West Mokoan Solar Farm

Surface Water Assessment

Client: 892 Yarrawonga Development Pty Ltd

AECOM Australia Pty Ltd

Figure 1: Flood overlay controls (Benalla Planning Scheme) and 1% AEP flood level contour adjacent to the site.

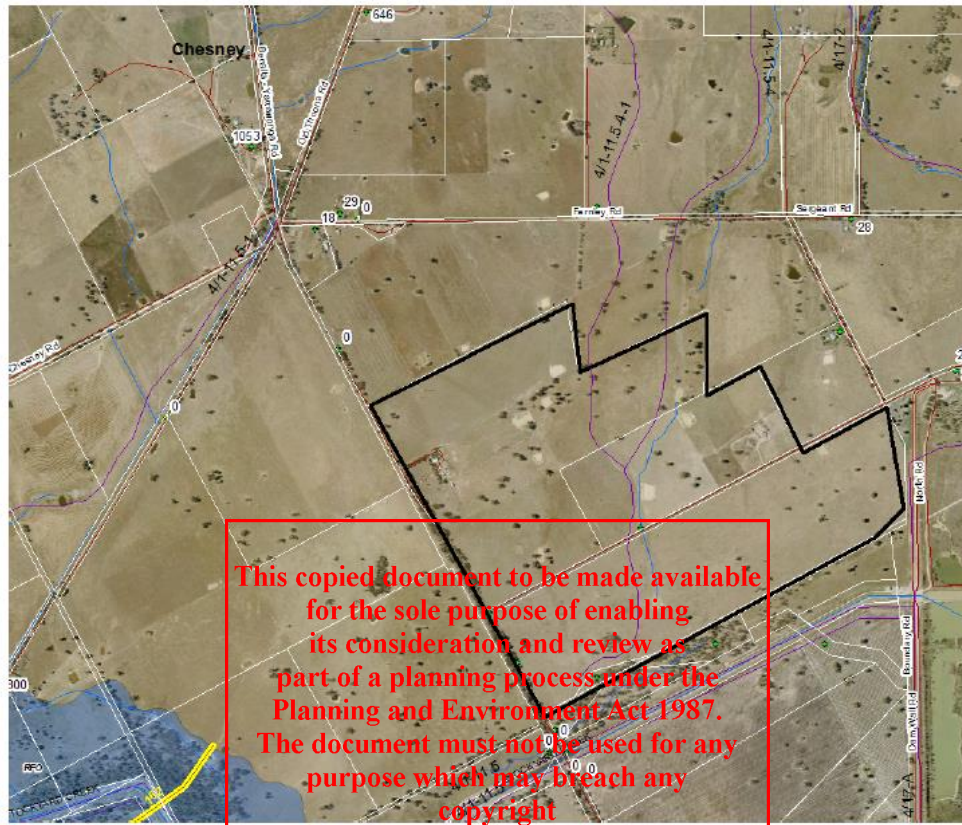
The Goulburn Broken CMA does not have any flood or detailed ground level information for the site. However, information derived from the 1993 flood (which is representative of the 1% AEP flood adjacent to the site is shown in **Figure 1**. This figure also depicts designated waterways that traverse through the site, which should remain free from obstruction.

1. Inverter and transformer blocks, any buildings, infrastructure and solar panels must be located a minimum of 30 metres from the nearest top of bank of the waterway shown in Figure 1.
2. The finished floor levels of inverter and transformer blocks and any buildings are to be set at least 450 millimetres above general surrounding ground level.
3. The corridors along the waterway shown in Figure 1 shall be revegetated in accordance with the Revegetation Guide for the Goulburn Broken Catchment (<https://revegetation.gbcma.vic.gov.au/>).
4. Where fencing crosses the waterway shown in Figure 1 the fencing shall be designed such that it does not obstruct flood flows. For example, farm type fencing, large open mesh (150 mm centres), vertical pool style fencing (150mm centres), fencing that lifts with the floodwater or similar.

Note, where access roads cross the waterway shown in Figure 1 a works on waterways permit will be required from the Goulburn Broken CMA.

Figure 1: Showing estimated 1% AEP flood contours and designated waterways.

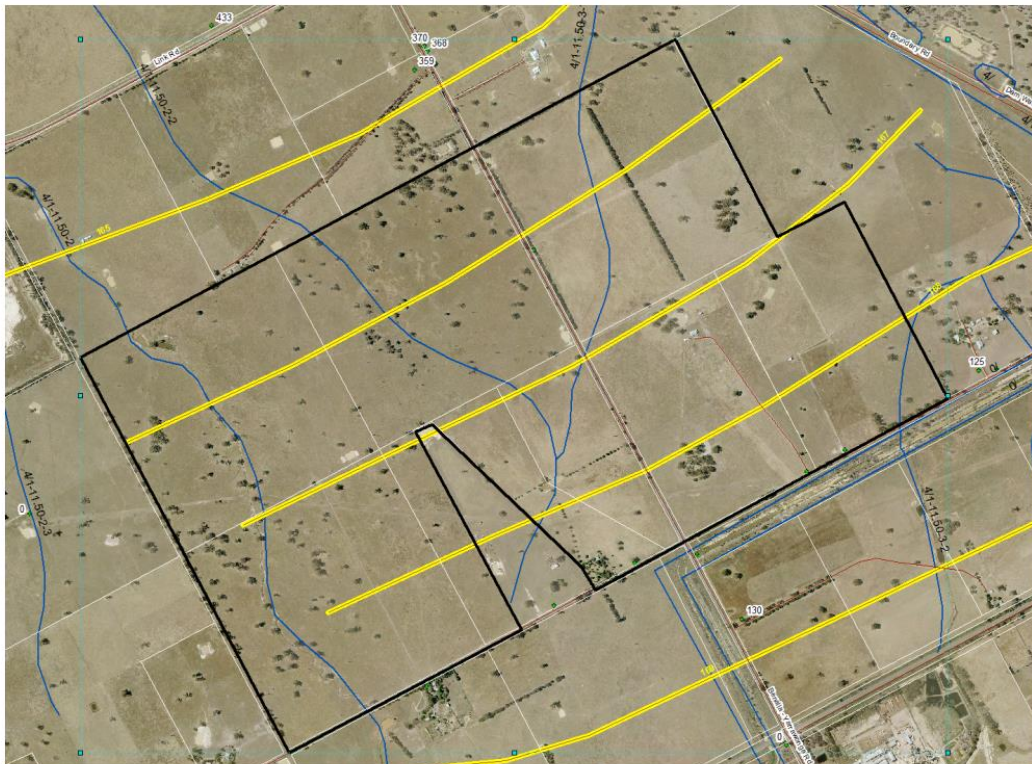
The Authority's best estimate of the 1% AEP flood levels for the location described above varies from 165.5 and 168.5 metres AHD (see Figure 1), which was established from limited 1993 flood levels. The Authority has no detailed ground level information to determine depths of flooding over the site.

Figure 1 also shows a number of designated waterways that traverse through the site. In this regard, the waterways should remain free from obstruction with vegetated corridors.

1. Inverter and transformer blocks, any buildings, infrastructure and solar panels must be located a minimum of 30 metres from the nearest top of bank of the waterway shown in Figure 1.
2. The finished floor levels of inverter and transformer blocks and any buildings are to be set at least 300 millimetres above the applicable 1% AEP flood level as shown in Figure 1.

3. The corridors along all waterways, as shown in Figure 1, shall be revegetated in accordance with the Revegetation Guide for the Goulburn Broken Catchment (<https://revegetation.gbcma.vic.gov.au/>).
4. Where fencing crosses waterways, as shown in Figure 1, the fencing shall be designed such that it does not obstruct flood flows. For example, farm type fencing, large open mesh (150 mm centres), vertical pool style fencing (150mm centres), fencing that lifts with the floodwater or similar.

Note, where access roads cross the waterway shown in Figure 1 a works on waterways permit will be required from the Goulburn Broken CMA.

Figure 1: Flood overlay controls (Benalla Planning Scheme) and 1% AEP flood level contour adjacent to the site.

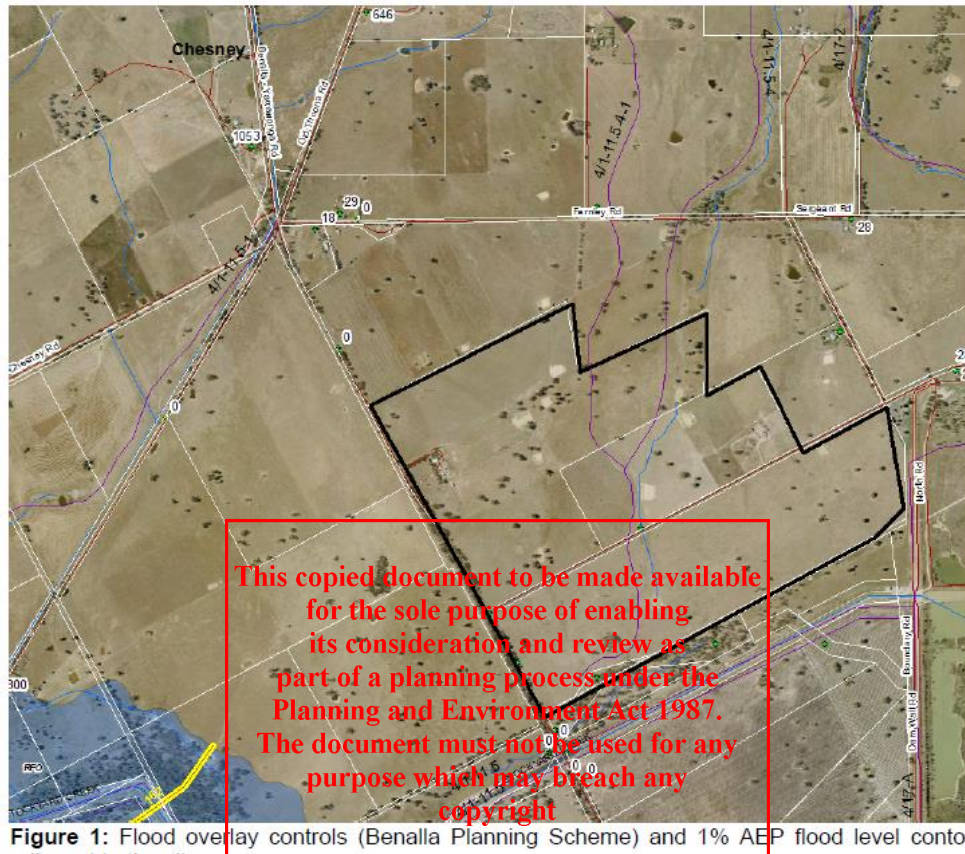
The Goulburn Broken CMA does not have any flood or detailed ground level information for the site. However, information derived from the 1993 flood (which is representative of the 1% AEP flood adjacent to the site is shown in **Figure 1**. This figure also depicts designated waterways that traverse through the site, which should remain free from obstruction.

1. Inverter and transformer blocks, any buildings, infrastructure and solar panels must be located a minimum of 30 metres from the nearest top of bank of the waterway shown in Figure 1.
2. The finished floor levels of inverter and transformer blocks and any buildings are to be set at least 450 millimetres above general surrounding ground level.
3. The corridors along the waterway shown in Figure 1 shall be revegetated in accordance with the Revegetation Guide for the Goulburn Broken Catchment (<https://revegetation.gbcma.vic.gov.au/>).
4. Where fencing crosses the waterway shown in Figure 1 the fencing shall be designed such that it does not obstruct flood flows. For example, farm type fencing, large open mesh (150 mm centres), vertical pool style fencing (150mm centres), fencing that lifts with the floodwater or similar.

Note, where access roads cross the waterway shown in Figure 1 a works on waterways permit will be required from the Goulburn Broken CMA.

Figure 1: Showing estimated 1% AEP flood contours and designated waterways.

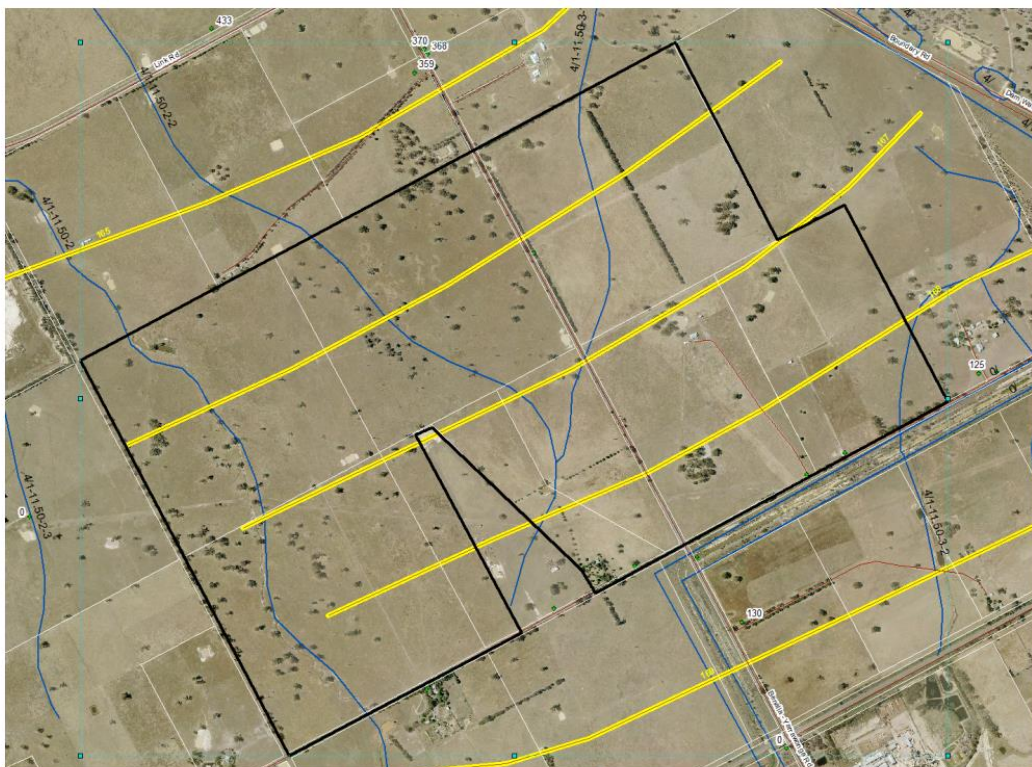
The Authority's best estimate of the 1% AEP flood levels for the location described above varies from 165.5 and 168.5 metres AHD (see Figure 1), which was established from limited 1993 flood levels. The Authority has no detailed ground level information to determine depths of flooding over the site.

Figure 1 also shows a number of designated waterways that traverse through the site. In this regard, the waterways should remain free from obstruction with vegetated corridors.

1. Inverter and transformer blocks, any buildings, infrastructure and solar panels must be located a minimum of 30 metres from the nearest top of bank of the waterway shown in Figure 1.
2. The finished floor levels of inverter and transformer blocks and any buildings are to be set at least 300 millimetres above the applicable 1% AEP flood level as shown in Figure 1.

3. The corridors along all waterways, as shown in Figure 1, shall be revegetated in accordance with the Revegetation Guide for the Goulburn Broken Catchment (<https://revegetation.gbcma.vic.gov.au/>).
4. Where fencing crosses waterways, as shown in Figure 1, the fencing shall be designed such that it does not obstruct flood flows. For example, farm type fencing, large open mesh (150 mm centres), vertical pool style fencing (150mm centres), fencing that lifts with the floodwater or similar.

Note, where access roads cross the waterway shown in Figure 1 a works on waterways permit will be required from the Goulburn Broken CMA.

Figure 1: Showing estimated 1% AEP flood contours and designated waterways.

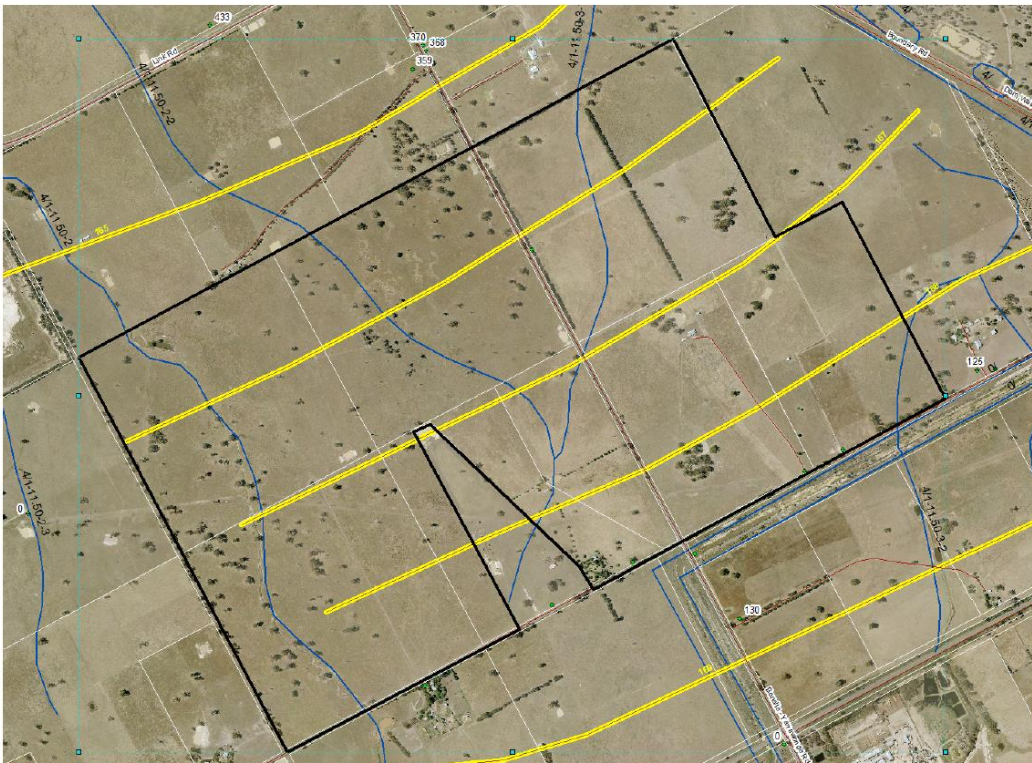
The Authority's best estimate of the 1% AEP flood levels for the location described above varies from 165.5 and 168.5 metres AHD (see Figure 1), which was established from limited 1993 flood levels. The Authority has no detailed ground level information to determine depths of flooding over the site.

Figure 1 also shows a number of designated waterways that traverse through the site. In this regard, the waterways should remain free from obstruction with vegetated corridors.

1. Inverter and transformer blocks, any buildings, infrastructure and solar panels must be located a minimum of 30 metres from the nearest top of bank of the waterway shown in Figure 1.
2. The finished floor levels of inverter and transformer blocks and any buildings are to be set at least 300 millimetres above the applicable 1% AEP flood level as shown in Figure 1.

3. The corridors along all waterways, as shown in Figure 1, shall be revegetated in accordance with the Revegetation Guide for the Goulburn Broken Catchment (<https://revegetation.gbcma.vic.gov.au/>).
4. Where fencing crosses waterways, as shown in Figure 1, the fencing shall be designed such that it does not obstruct flood flows. For example, farm type fencing, large open mesh (150 mm centres), vertical pool style fencing (150mm centres), fencing that lifts with the floodwater or similar.

Note, where access roads cross the waterway shown in Figure 1 a works on waterways permit will be required from the Goulburn Broken CMA.
